Draft amendments to UNECE Regulation No. 29
(Passive safety for cargo vehicle cabin passengers)

Fig.1. Front part strength testing (Test A)**Fig.2. Roof strength testing (Test B)**

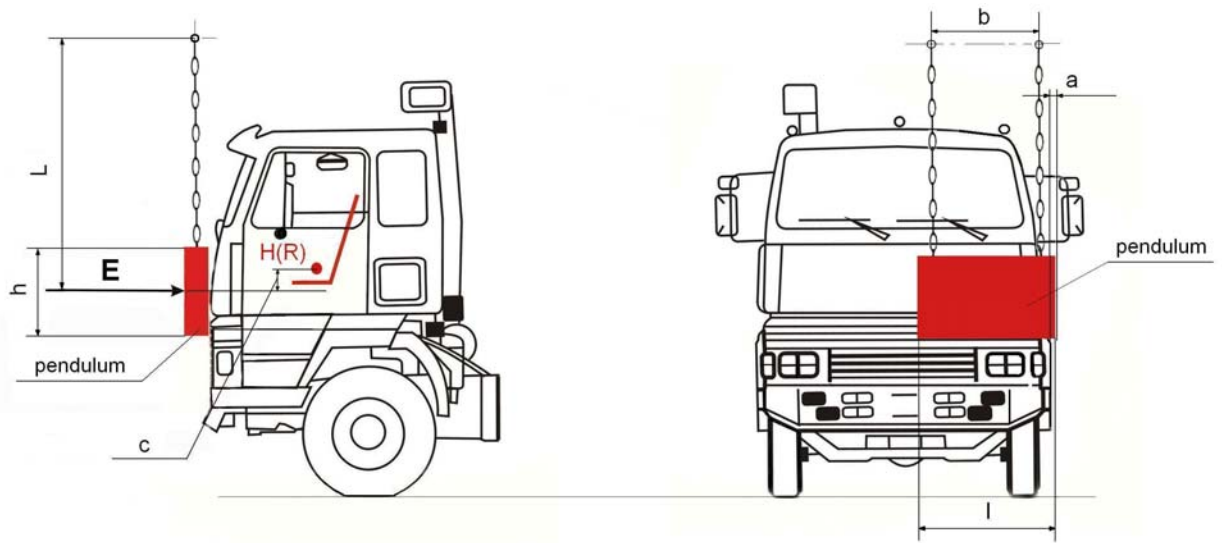
- 4.1.2 **The pendulum must be rigid and hang freely on two chains, so that there would be at least b=800 mm distance between the chain attachment points. The minimum chain length measured from the hanger bracket axis to the geometric center of the pendulum must be 3 500 mm.**

- 4.1.3.3 **The outer side rim of the pendulum must be placed between two parallel vertical planes separated by a=30 mm space. The inner plane must be parallel with the middle longitudinal plane and tangent to the outer surface of the driver's door.**

4.2.1 The pendulum must strike the cabin while moving from front to back. The strike direction must be horizontal and parallel with the middle longitudinal section of the vehicle. **(Fig. 1). The energy of the strike must equal 40 kJ for N₃, [30] kJ for N₂, and [25] kJ for N₁ vehicles**

Fig.3. Back part strength testing (Test C)

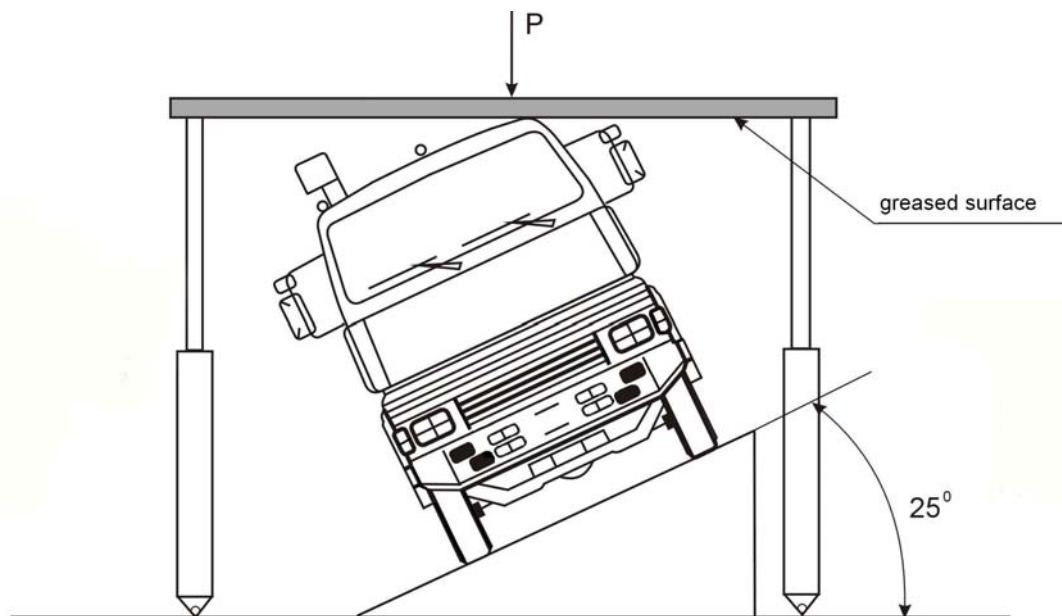
6.1.2 **The pendulum must be rigid and hang freely on two chains, so that there would be at least $b=800$ mm distance between the attachment points of the chains. The minimum chain length "L" measured from the hanger bracket axis to the geometric center of the pendulum must be 3 500 mm.**

The pendulum must strike the driver's cab from the back and be directed to the front (Fig. 3). The strike direction must be horizontal and parallel with the central longitudinal section plane of the vehicle. The center of the strike must coincide with the central axial plane of the back wall and be located in the middle point between the floor and the roof of the cabin. The energy of the strike must equal 30 kJ for N₃, [20] kJ for N₂, and [15] kJ for N₁ vehicles.
